RE: Staff Review Comments for Preliminary Level II Site Plan

Project Name: Century Tire Plaza  
Address: 195 Kennebec Street  
Applicant: Northland Enterprises, LLC  
Planner: Nell Donaldson

Project ID: 2015-027  
CBLs: 34-C-9

**BOUNDARY SURVEY**  
ON  
MARGINAL WAY, KENNEBEC STREET & FOREST AVENUE  
PORTLAND, MAINE  
MADE FOR  
**ATLANTIC NATIONAL TRUST**  
50 PORTLAND PIER, SUIT 400, PORTLAND, MAINE

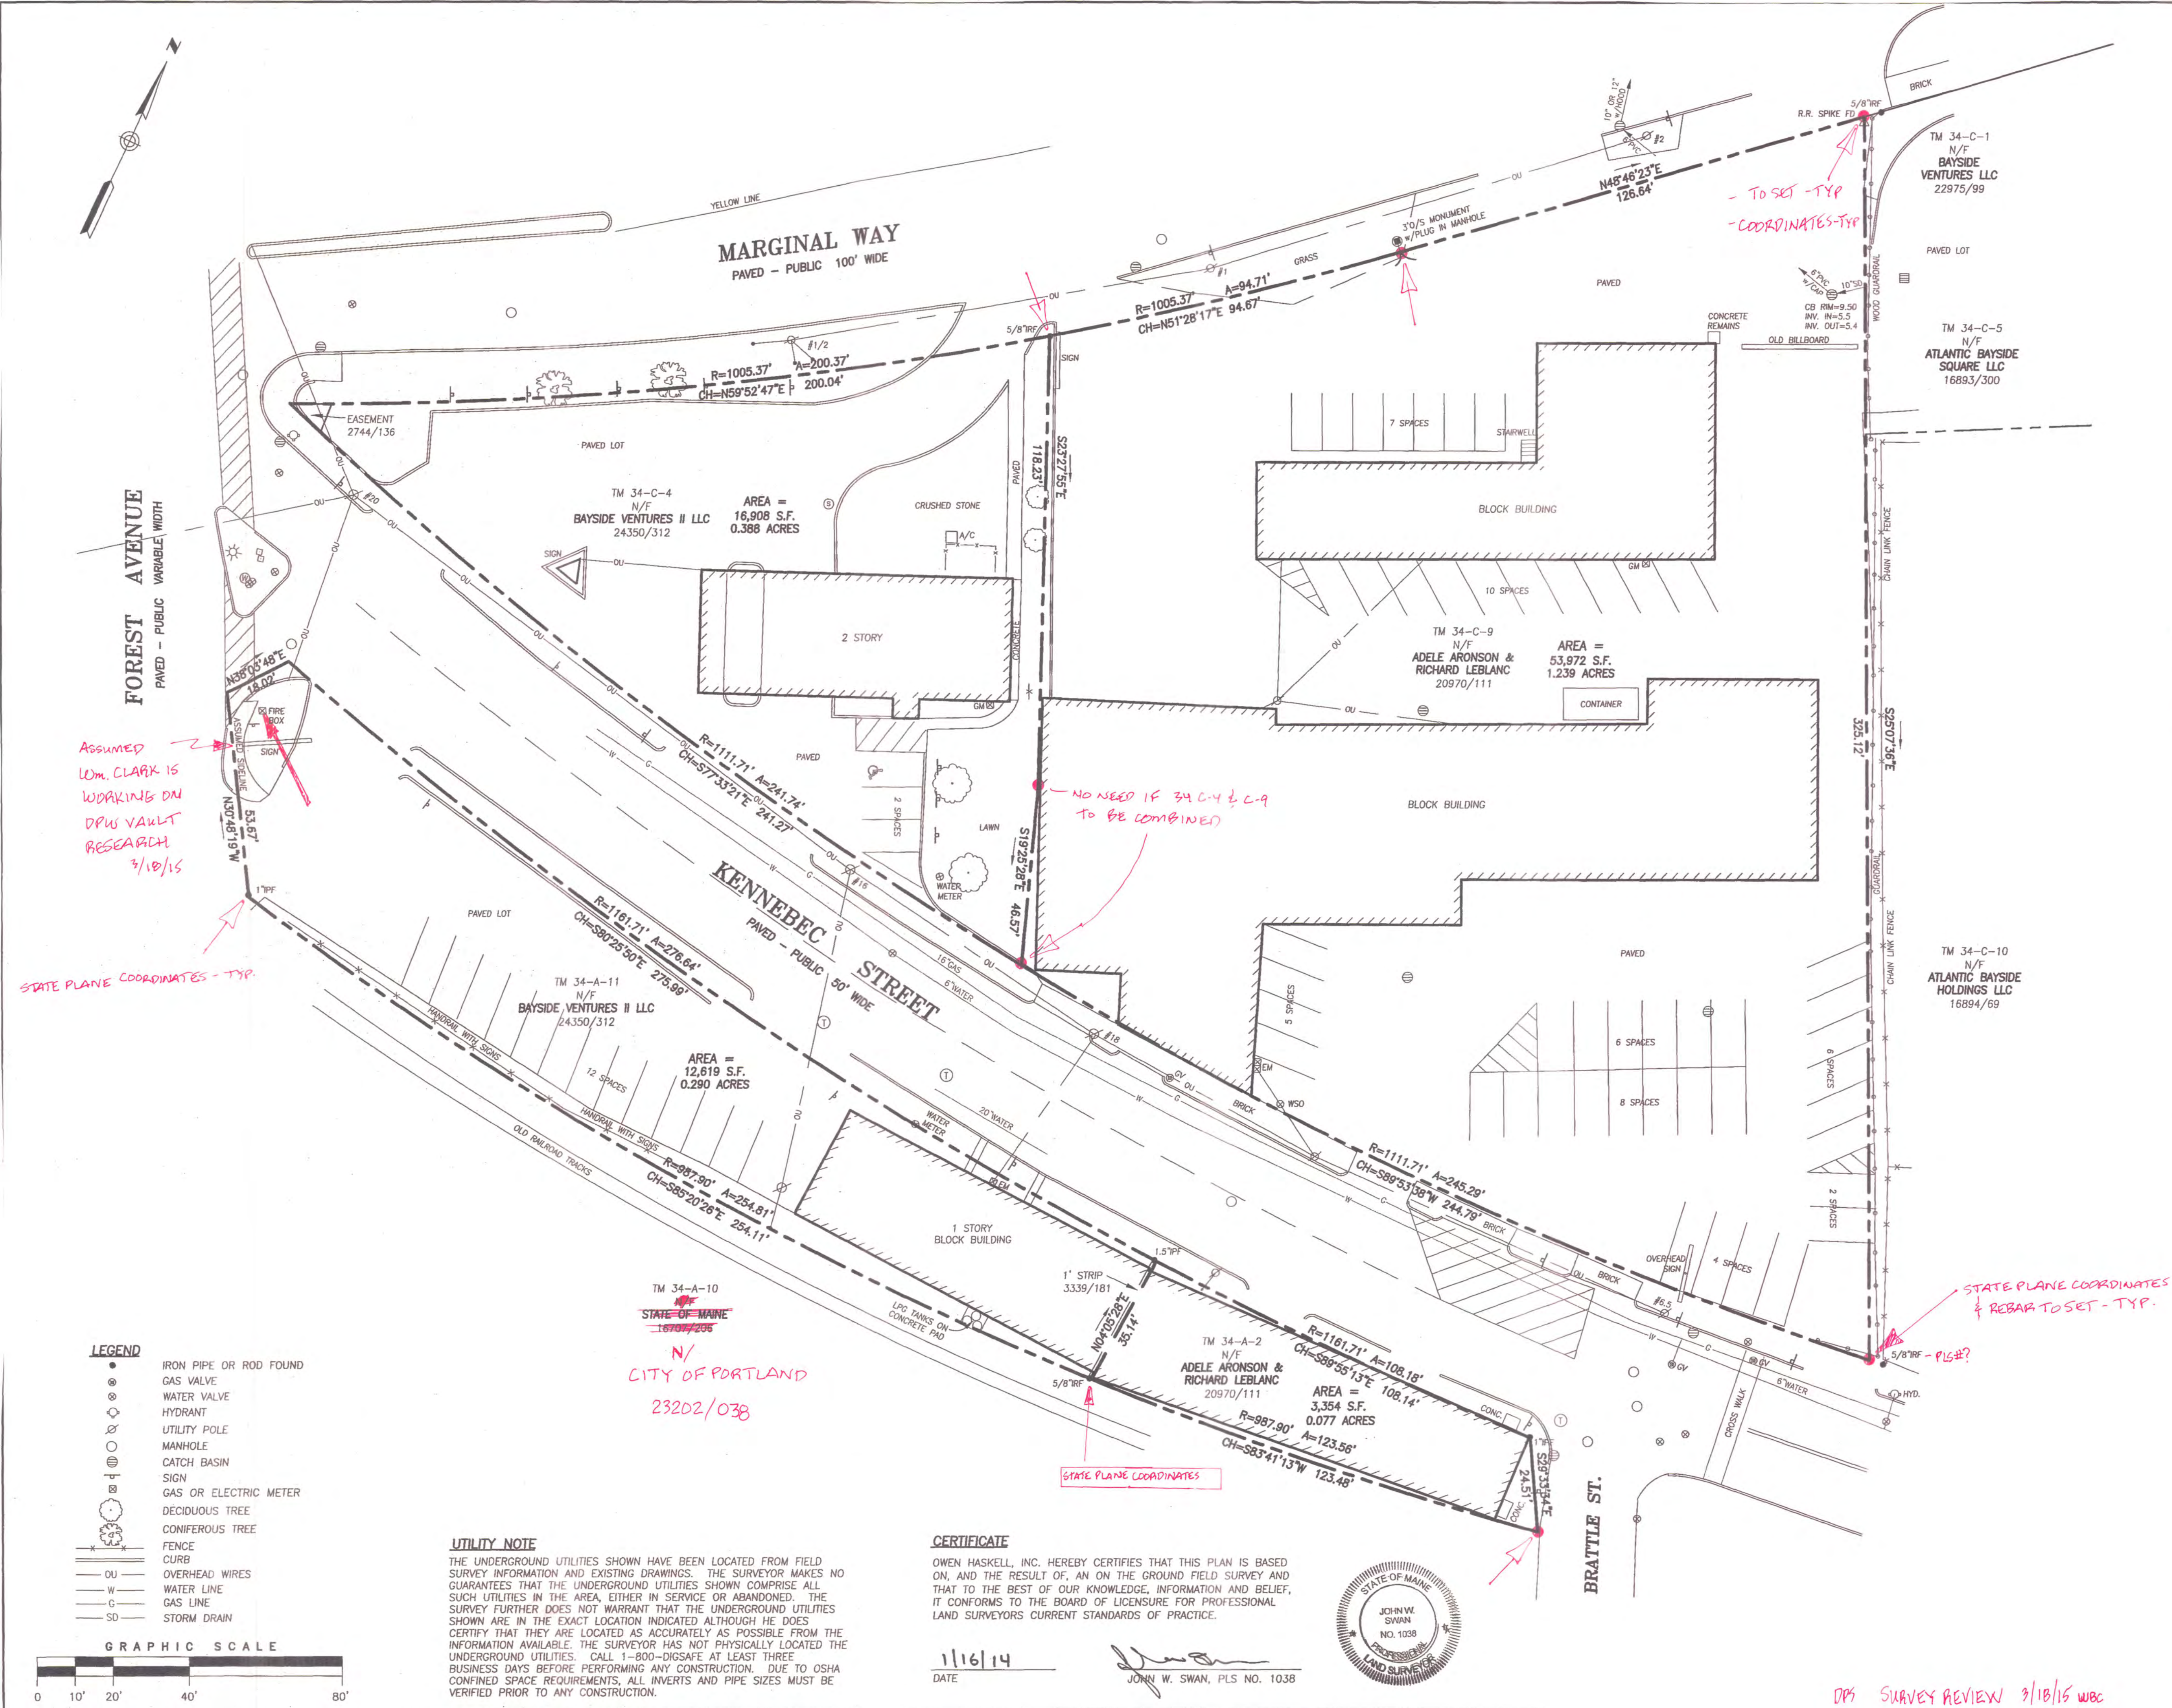
ASSUMED  
WM. CLARK IS  
WORKING ON  
DPW VAULT  
RESEARCH  
3/18/15

STATE PLANE COORDINATES - TYP.

NO NEED IF 34-C-4 & C-9  
TO BE COMBINED

STATE PLANE COORDINATES  
& REBAR TO SET - TYP.

DPW SURVEY REVIEW 3/18/15 wbc
